# SELECT STRUCTURAL

RE: Brick Wall Repair – Addendum  
324 N. Main St.  
Davenport, IA

Figure 2 – Brick Demo

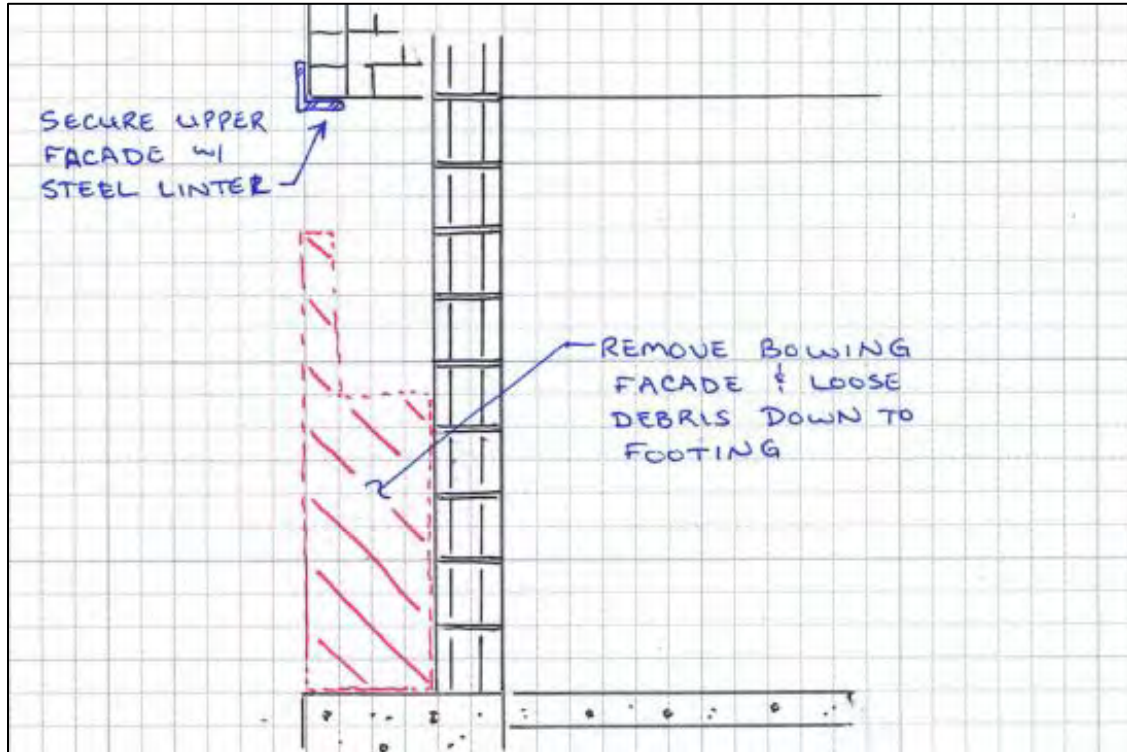
The Mason and Engineer agree that the most direct solution is to remove the brick façade in this area in a safe, controlled manner, and then to construct a second, outer layer of CMU from the ground level up to the top of the void (roughly 15 to 18 feet). This would allow the safe removal of unstable clay brick and add solid structure to the compromised wall. The repairs to the original twelve-foot-wide area of wall would proceed as it is now.
